**SOUTHERN NEVADA
PROPOSED AMENDMENTS**

**2012 INTERNATIONAL SWIMMING POOL
AND SPA CODE**

**POOL CODE COMMITTEE
SEPTEMBER 04, 2012**

Figure 680.8 Clearances from Pool Structures.

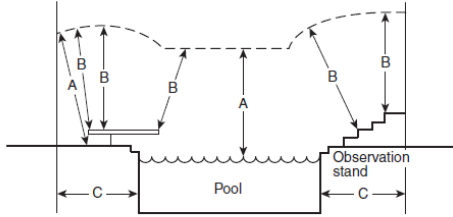
(A) Power. With respect to service drop conductors and open overhead wiring, swimming pool and similar installations shall comply with the minimum clearances given in Table 680.8 and illustrated in Figure 680.8.

Site work protection and site drainage are not addressed in the current code. This is from the 2009 code and is consistent with current practices. NEC section 680.8 was updated to current codes. It was felt that if we took the electrical requirements out pool builders would not look for these requirements and they would not show up in the design so they were maintained for clarity only.
